Preventing Thermal Lock in New Lancair Pumps installed in the 320/360

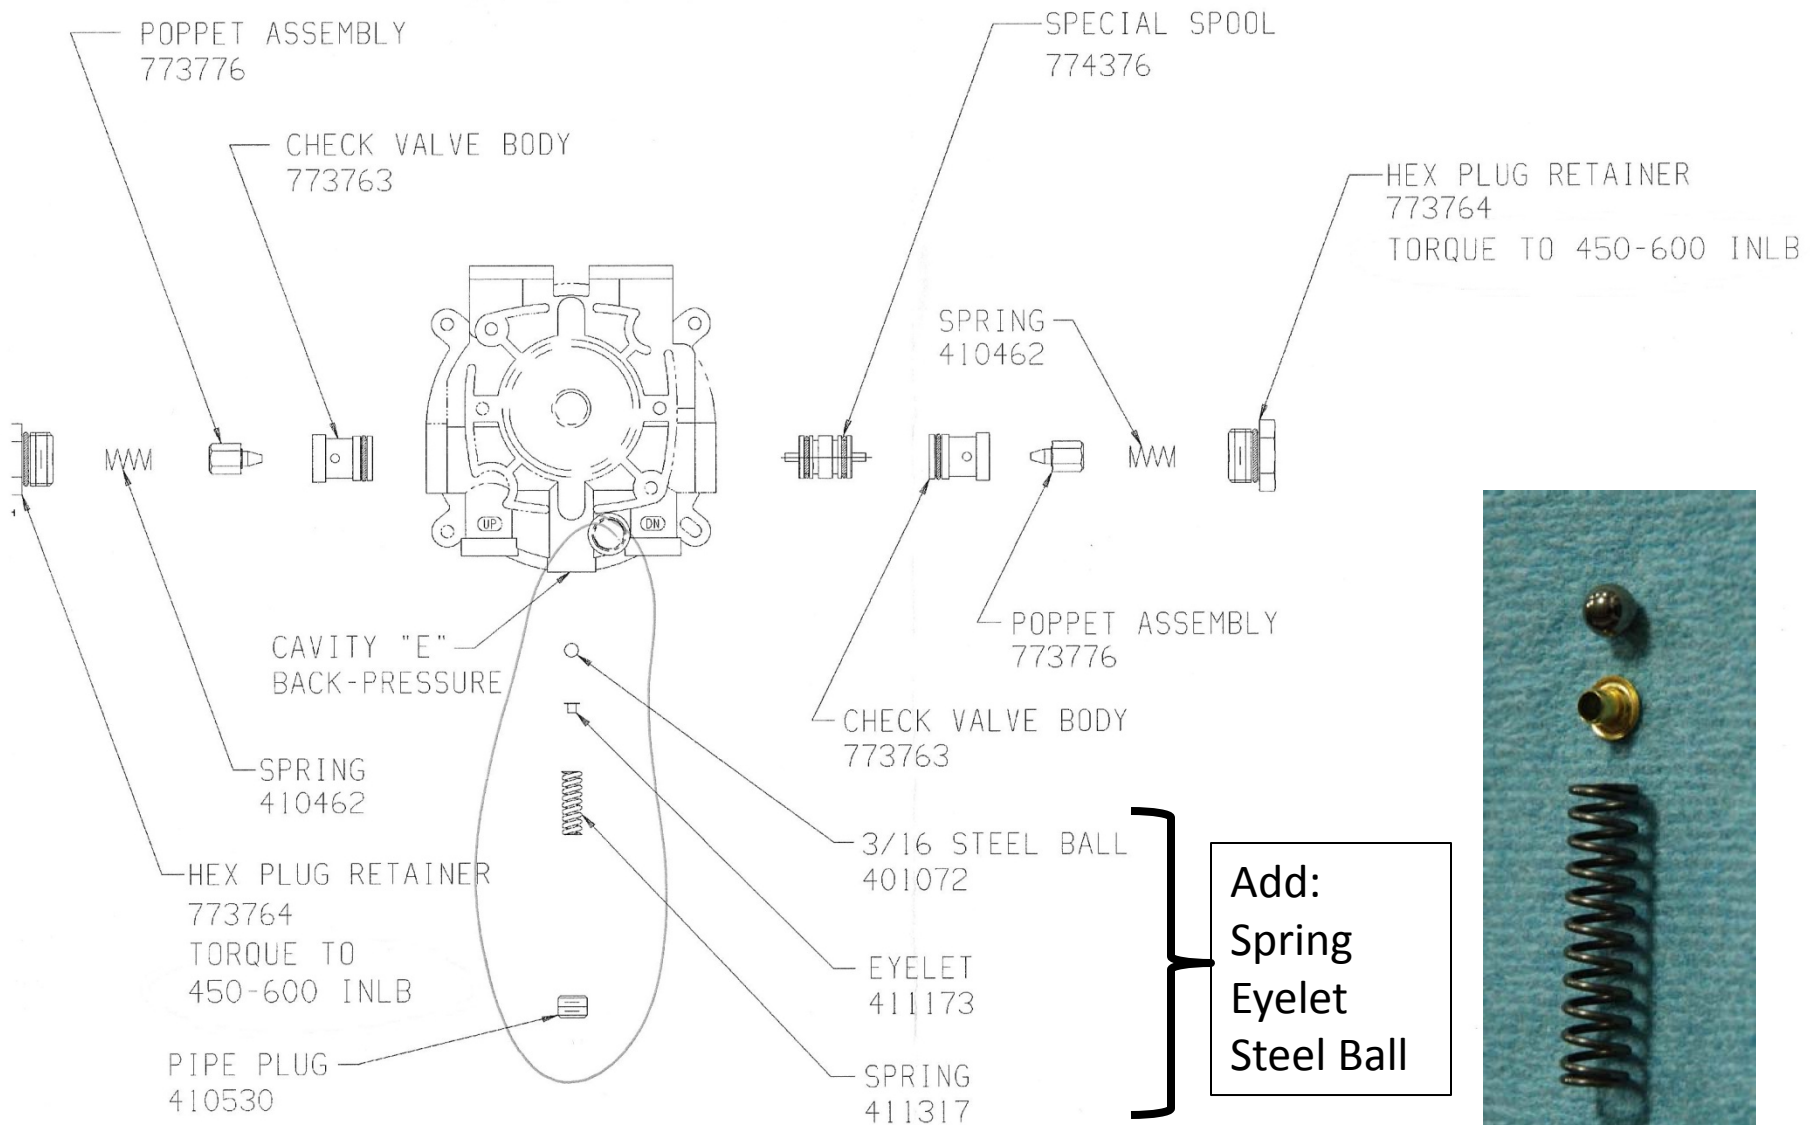
Two springs were added that center the spool after pump shut down. This has introduced the potential for complete system lock up in 320/360 if the hydraulic system is warmed sufficiently after parking the aircraft. Unfortunately this renders a stock aircraft unable to raise the gear. Unlocking the system requires either the pressure to be relieved by cracking a fitting or the pump must be forced on by-passing the pressure switches. The following video clip re-creates this phenomenon on the work bench.

In order to avoid this condition, the pump can be reverted back to the original configuration. The centering springs are removed and a back pressure valve is added. The following pages show the parts involved.

Remove Springs

**Add:
Spring
Eyelet
Steel Ball**
